## 6817 Greenwood

6817 Greenwood Ave N // Project# 3032404-LU  
Design Recommendation // Northwest Design Review Board  
Meeting Date // July 25th, 2022

6817 Greenwood Partners, LLC

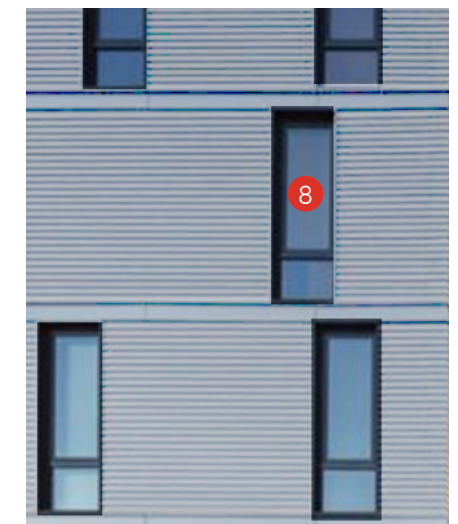
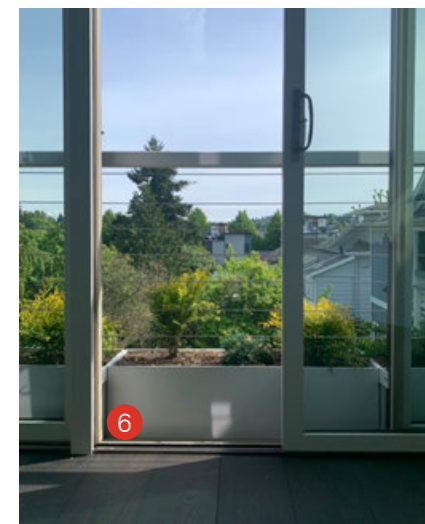
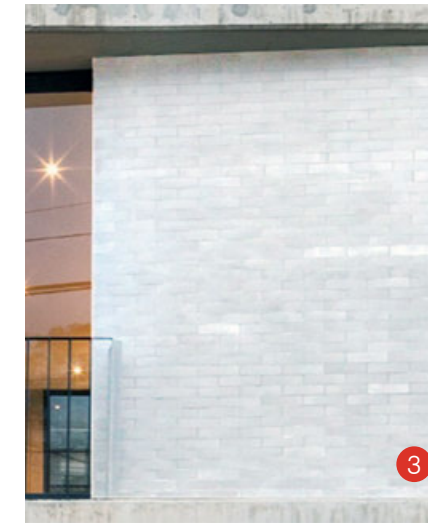
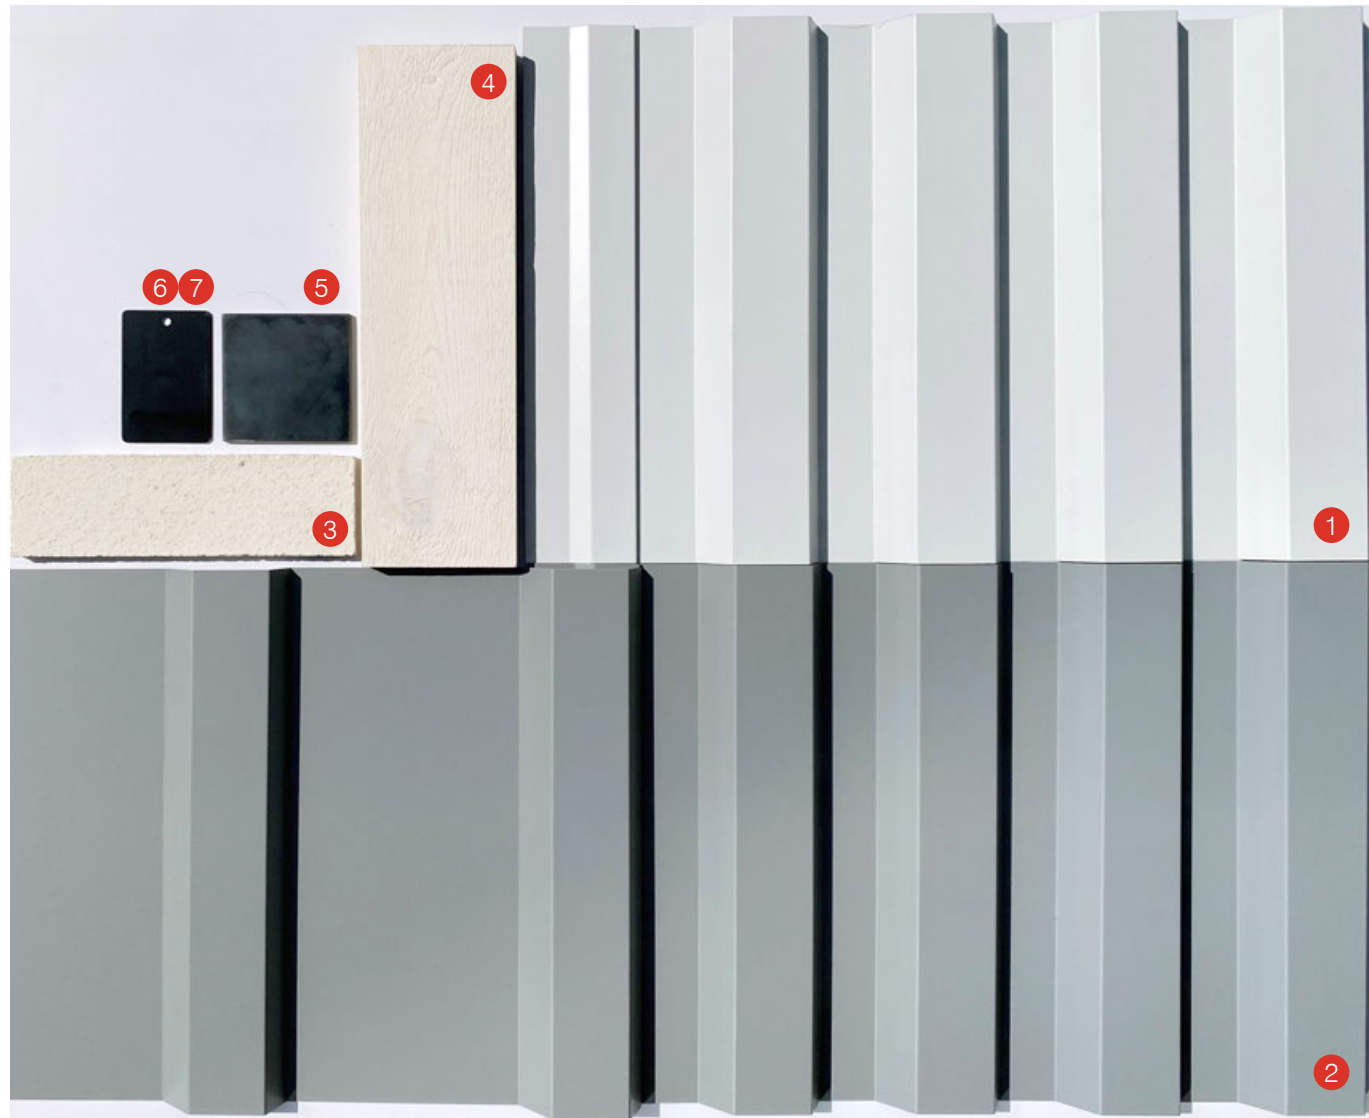
a. The Board recognized that materiality is an important part of the character of the Greenwood-Phinney neighborhood, particularly the use of brick and high-quality, long lasting materials. The Board recommended the use of these types of materials and stated that the material palette should be supported by in-depth contextual material studies at the Recommendation phase. (CS3-A-3, DC4-A-1, DC4-II-I of the Greenwood-Phinney Neighborhood Design Guidelines)

b. The Board noted the pedestrian experience, especially on such a narrow frontage, will be dictated by the material treatment. (CS3-A-3, DC4-A-1, DC4-II-I of the Greenwood-Phinney Neighborhood Design Guidelines)

**Brick, natural wood, textured metal siding, and steel balconies contribute to a high-quality and long lasting material palette.**

**Brick, natural wood, high quality pavers, landscaping and seating will create a rich pedestrian experience.**

west facade

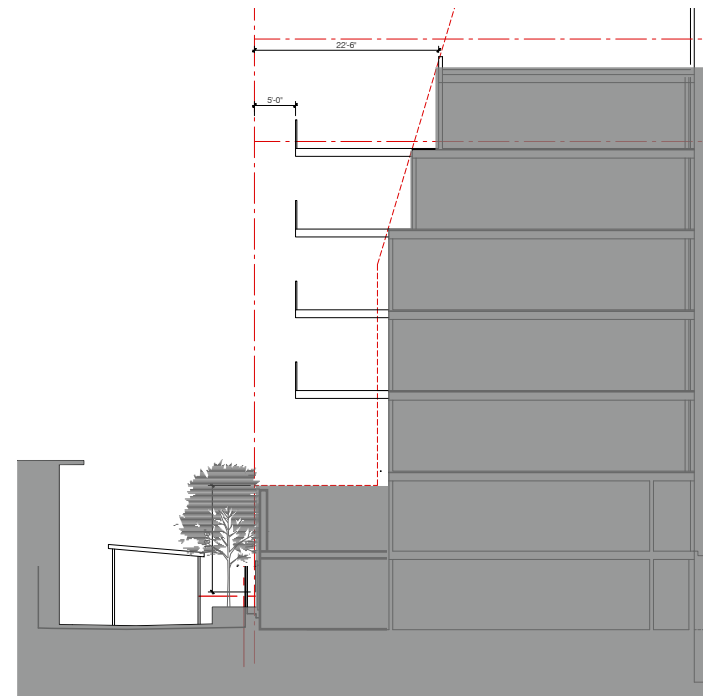
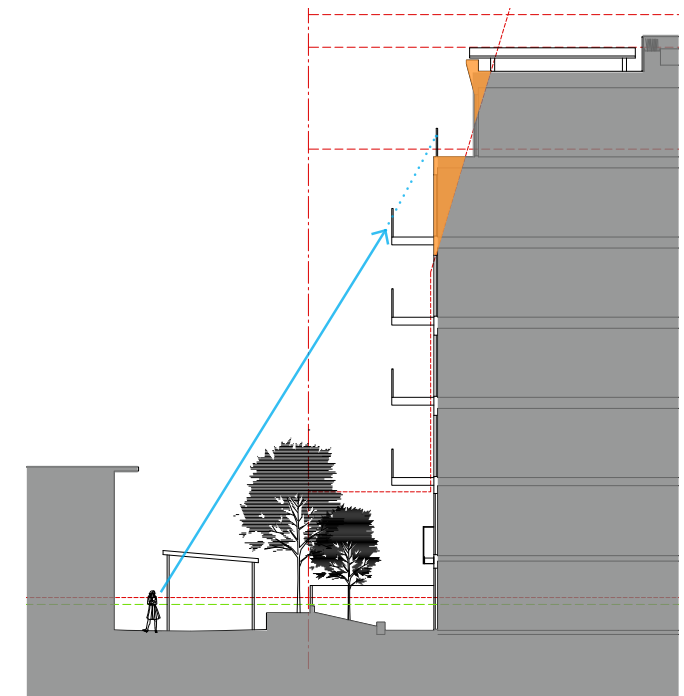
In order to provide a more open ground level, provide a consistent architectural expression, modulate the building mass, and create a datum at the fifth floor, we request a departure to provide a 15'-5" setback on the west facade. Note the setback is measured to the exterior wall of the building as open railings are proposed.

The exterior wall of the building will be located 15'-5" from the lot line up to level six, where it will step back to 19'-3". This creates a significant open space at ground level that will maintain the open feeling between the two lots. It will also allow for landscape elements near the lot line to provide visual screening between the lots and manage the privacy.

In keeping with the architectural concept, the façade and perimeter frame provide a consistent expression to the west façade. The setback sixth floor establishes a datum that reduces the perceived scale of the structure. 5 ft x 8.5 ft balconies with open railings are secondary elements on the façade that increase privacy from within the dwelling units without adding significant bulk to the façade.

north facade // birdseye view

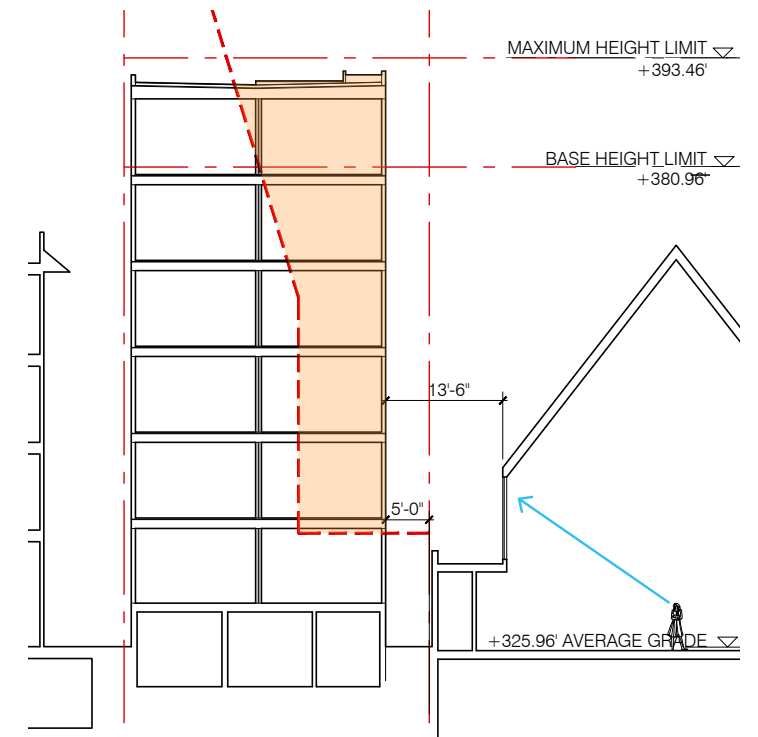
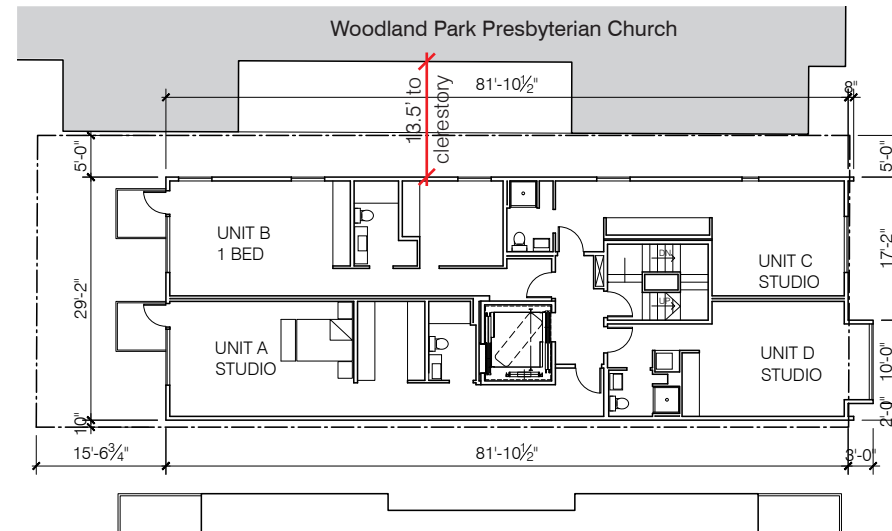
In order to provide a cohesive street facing façade, livable dwelling units, and an open space between the project and the Church we request a departure to provide a 5'-0" minimum upper-level setback for the entire north lot line.

As a small, midblock site, the project is constrained by access needs and an upper-level setback requirement on the west lot line. The site is further constrained by an upper-level setback requirement along the north lot line.

The proposed design provides a cohesive urban façade with the entire project set five feet away from the Church to provide open space and daylight to the sanctuary. This set back will provide 13.5 feet of separation between the translucent clerestory windows and the project. It will also allow for a limited number of windows on the north wall that will activate façade, create visual interest, and scale the façade as a backdrop to the Church. Light colored exterior materials will be used.
